# Change of SAR attenuator setting for ScanSAR mode

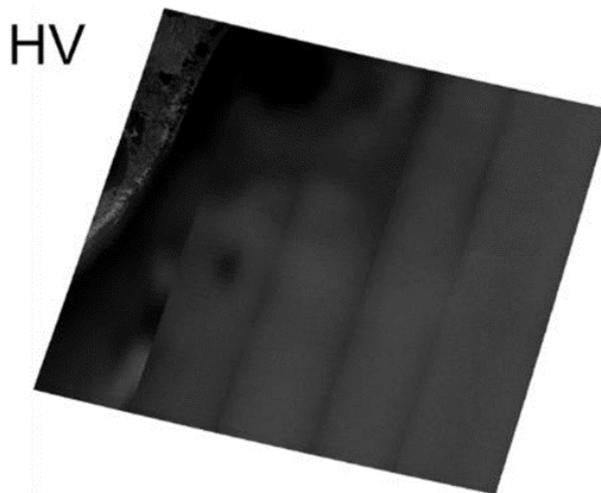
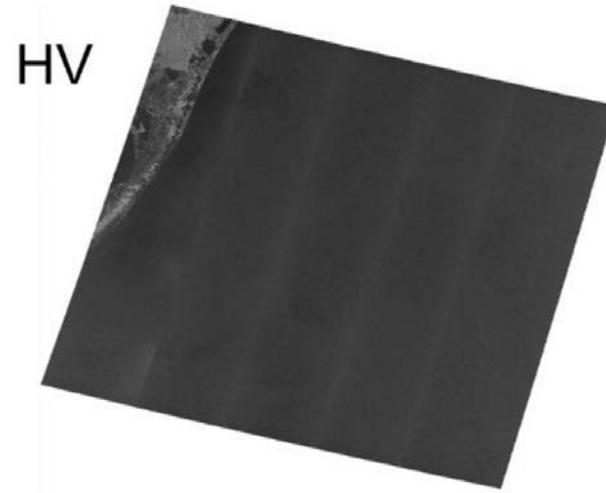
- It was found that the ScanSAR HV-polarization images sometimes became dark and blurred over ocean and coastal regions.
- The cause of this issue was that the onboard ATT (attenuator) setting for ScanSAR cross-polarization was higher.
- On April 11, 2018, the ATT setting for ScanSAR cross-polarization was changed to 20 dB.

**ATT 25dB**, 2016/7/24

**ATT 20dB**, 2017/12/10
